KTN WOLFE POINT SLOPE STABILITY IMPROVEMENTS

PROJECT NO. 0920(032)/SFHWY00432

GRADING AND SIDE SLOPE STABILIZATION

Record Drawings have been reviewed by the Project Engineer, and represent to the best of my knowledge, the project as constructed.

1 NORTH TONGASS TYPICAL SECTION
 B2 SCALE: NOT TO SCALE
 STA 17+50 TO STA 22+10

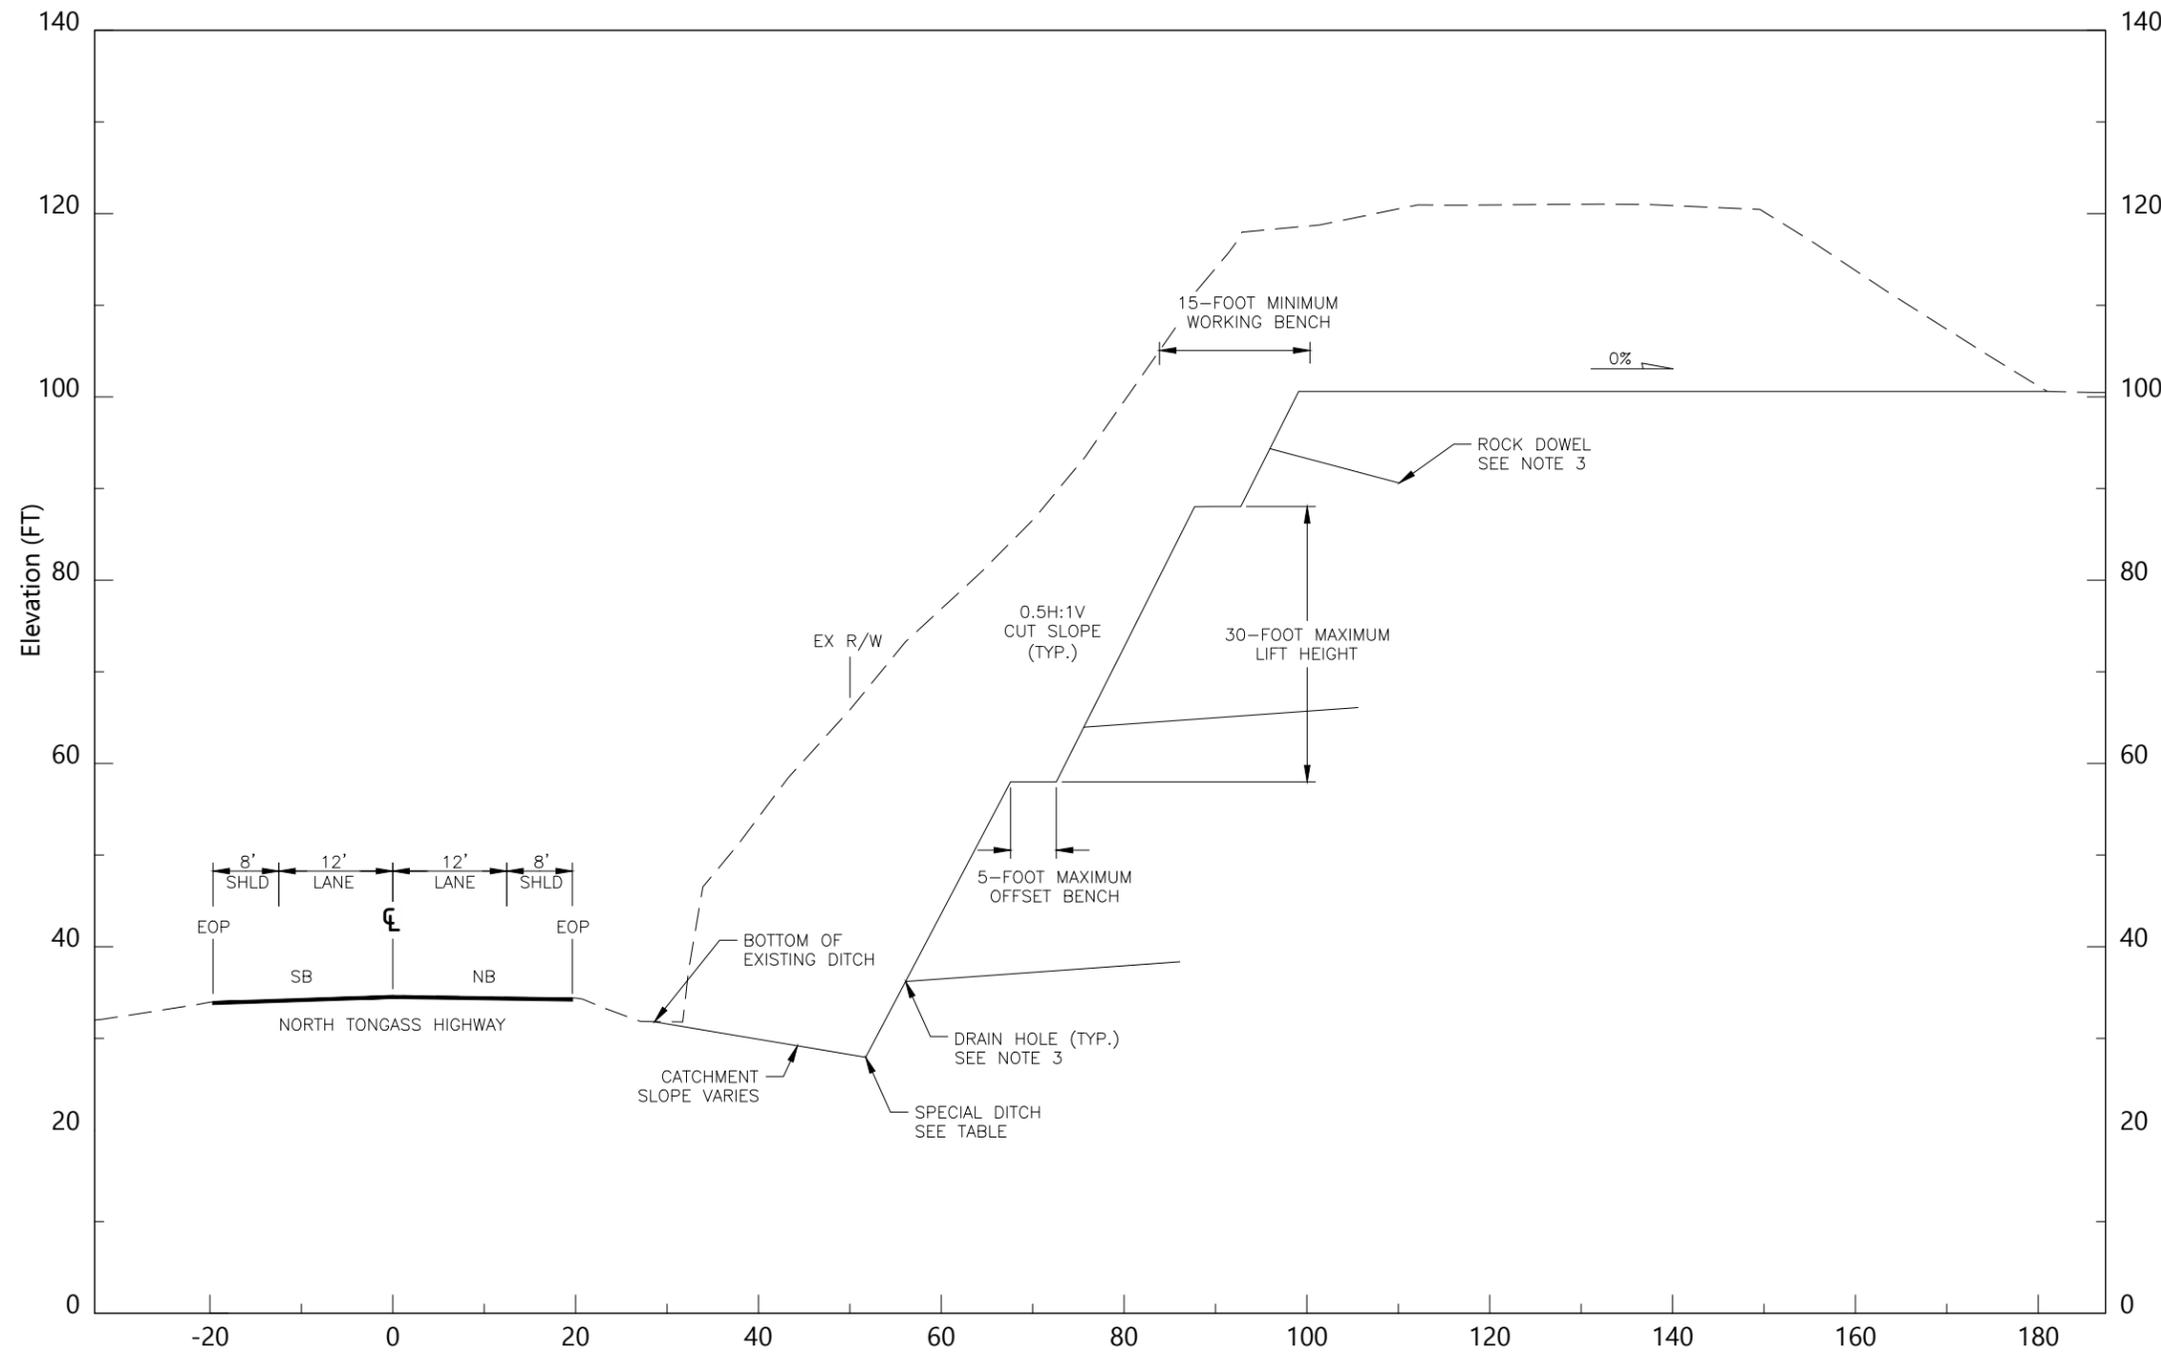
Revised Per CO 1

2
B3 PAVEMENT REPLACEMENT STRUCTURAL SECTION
SCALE: NOT TO SCALE

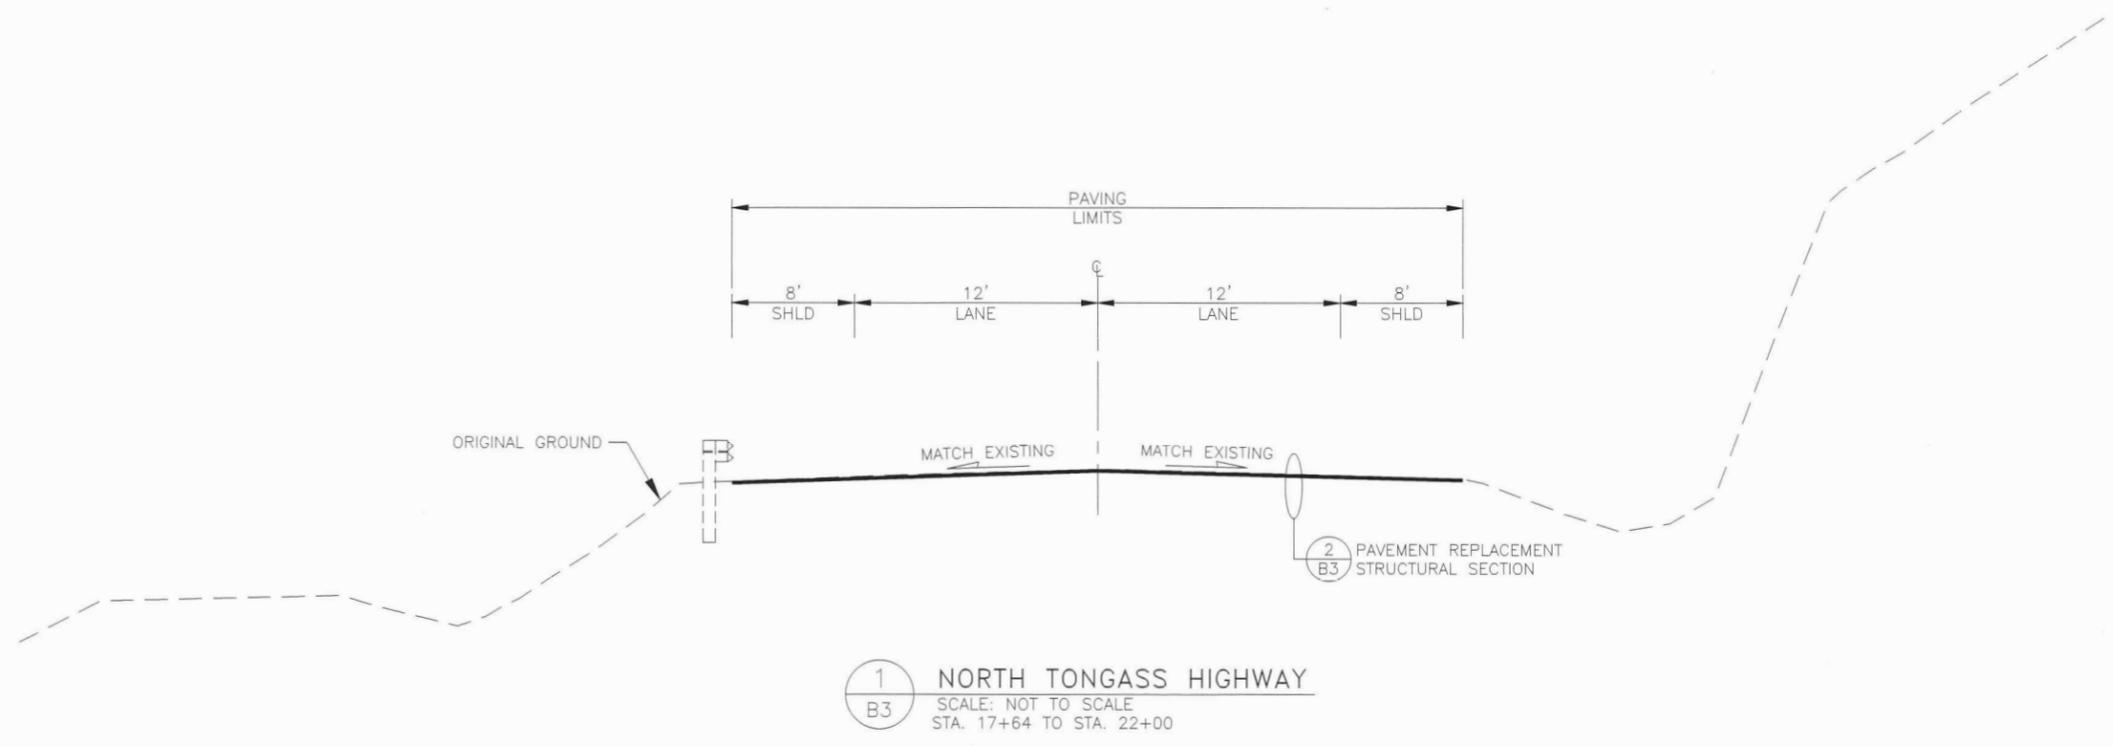
Deleted Per CO 08

CROSS SECTION A-A

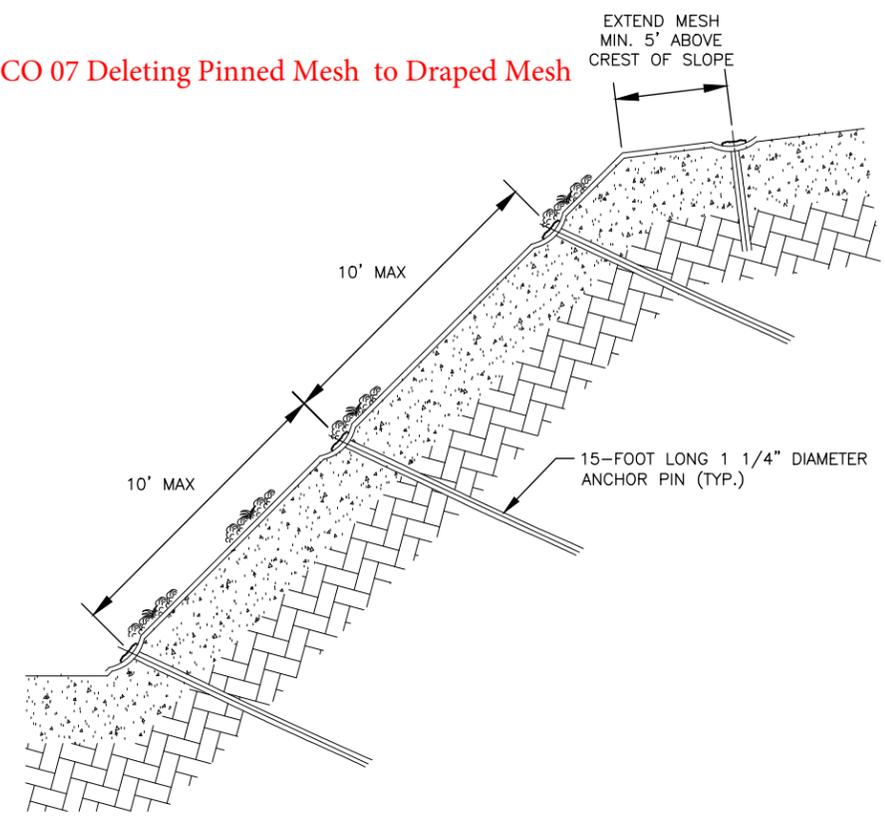
See CO 07 Deleting Pinned Mesh to Draped Mesh

STATE OF ALASKA DEPARTMENT OF TRANSPORTATION AND PUBLIC FACILITIES
 KTN WOLFE POINT SLOPE STABILITY IMPROVEMENTS
 17+00 TO EOP SITE PLAN

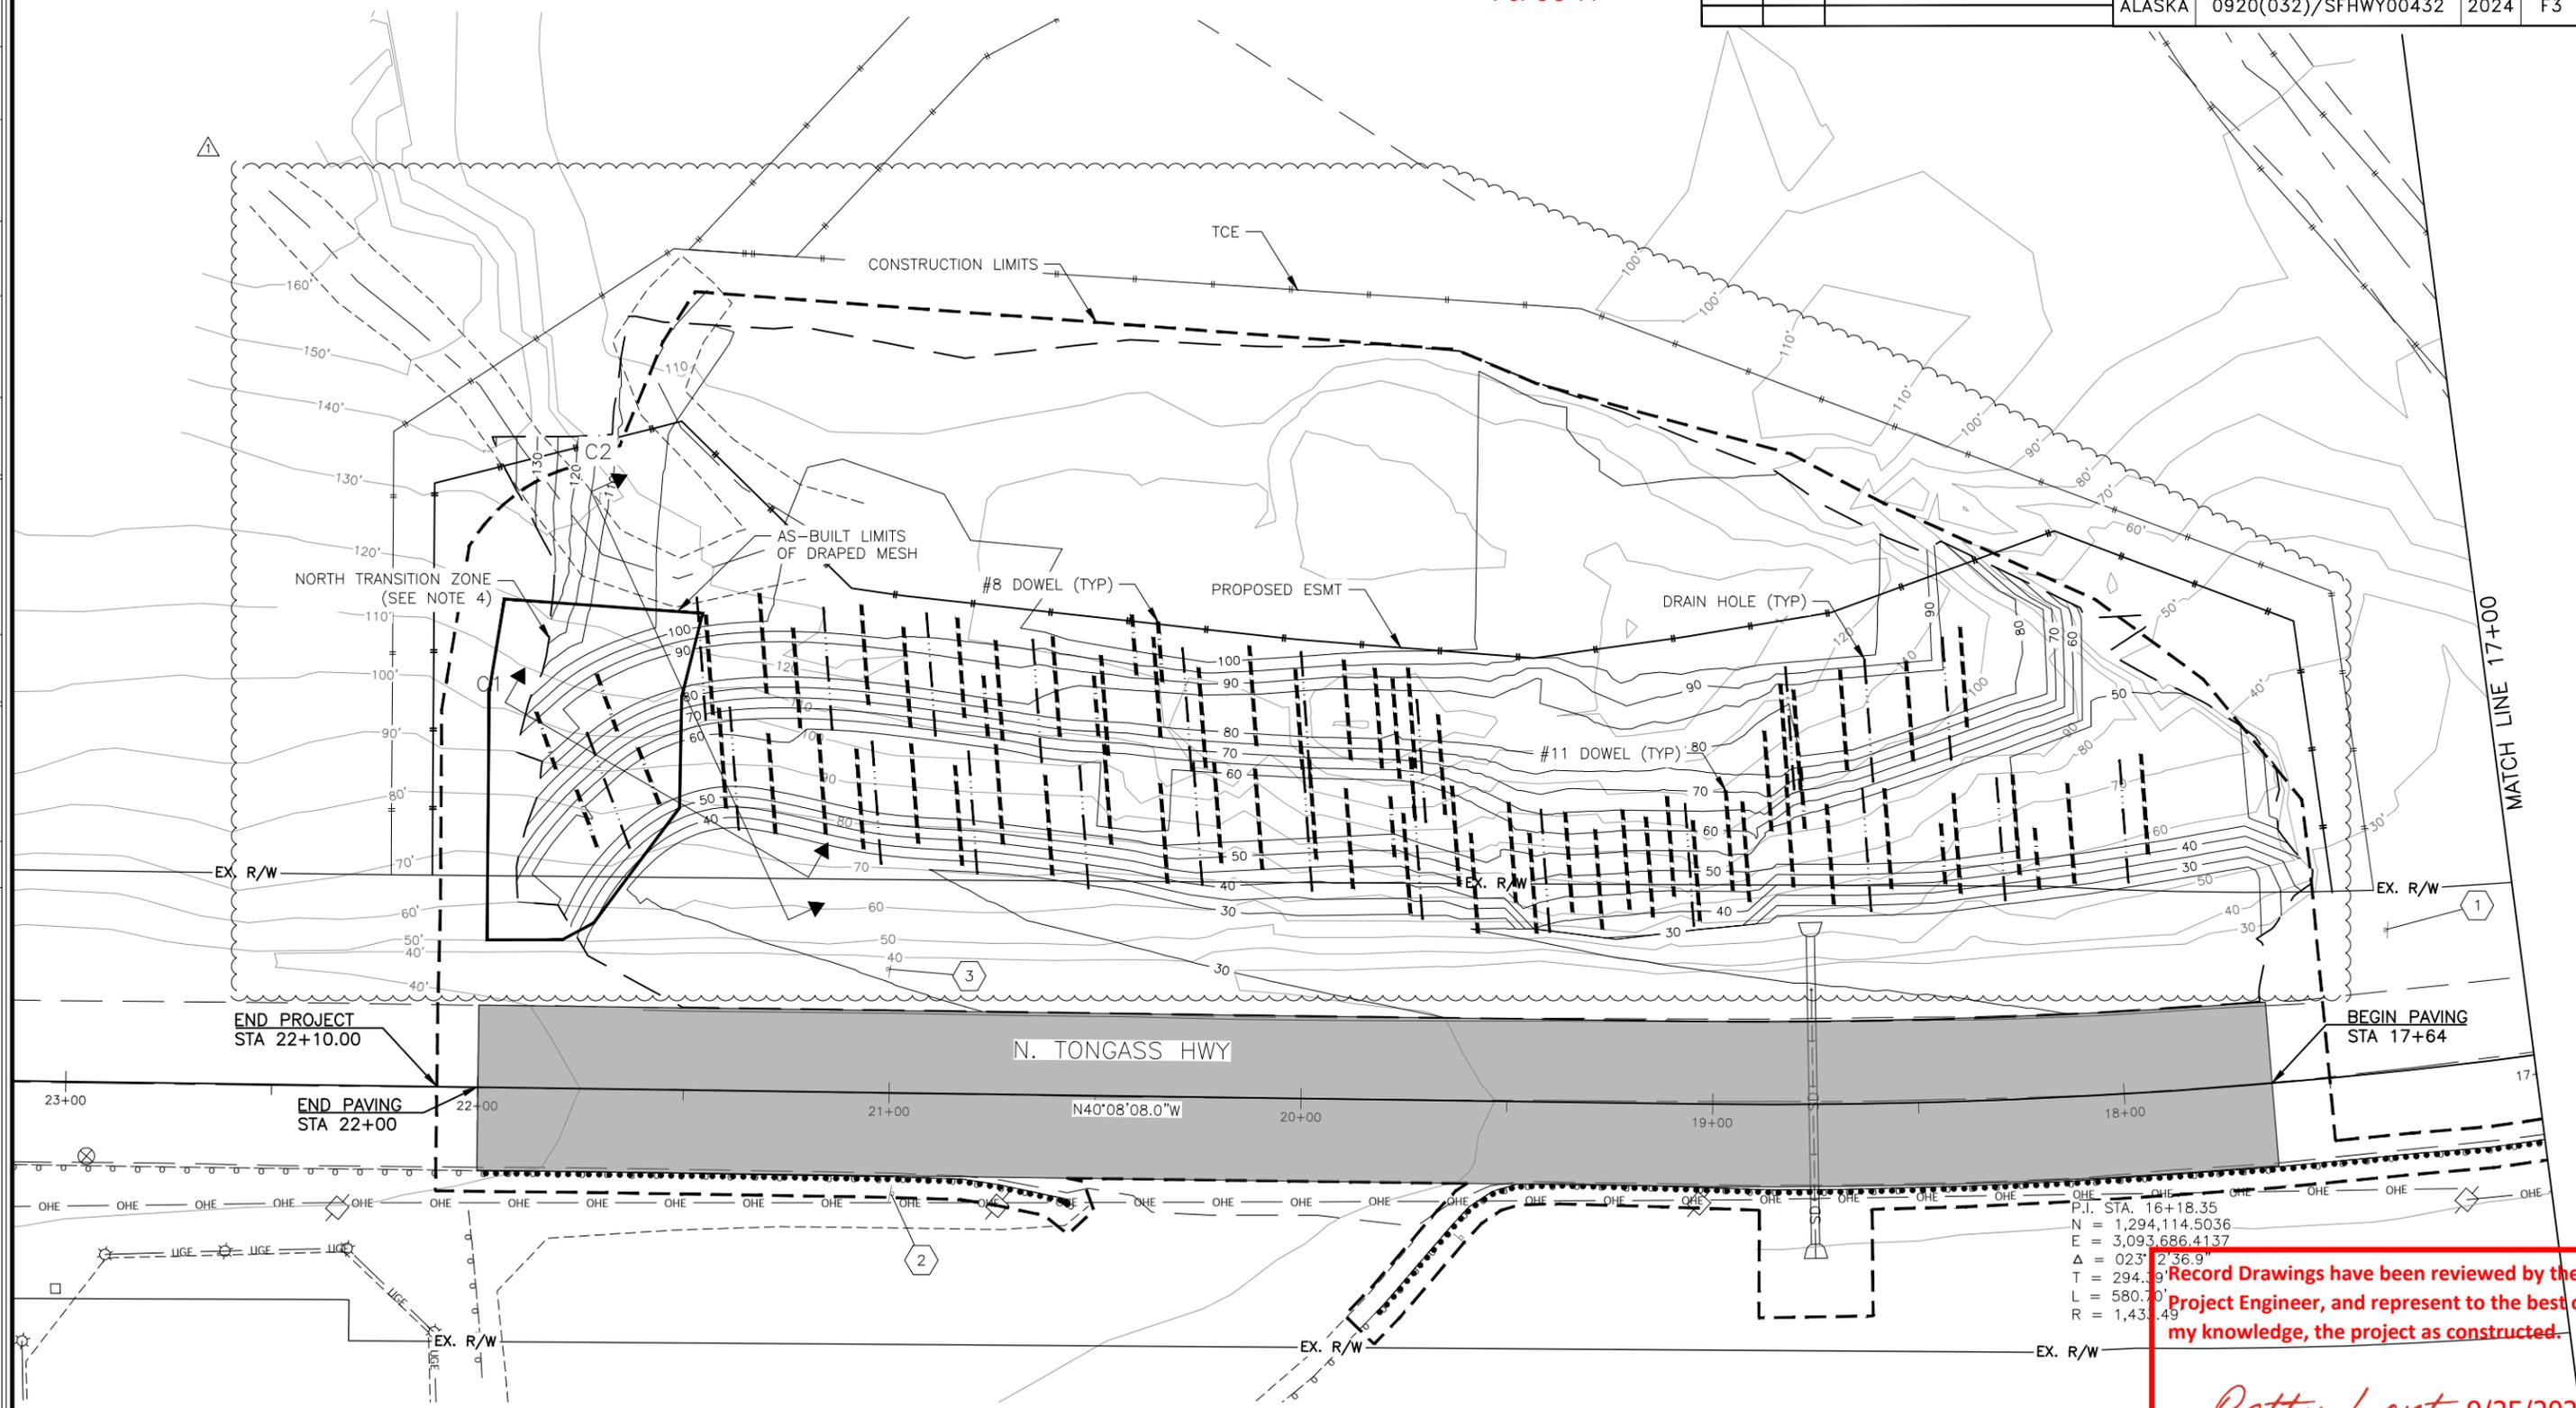
Per CO 11
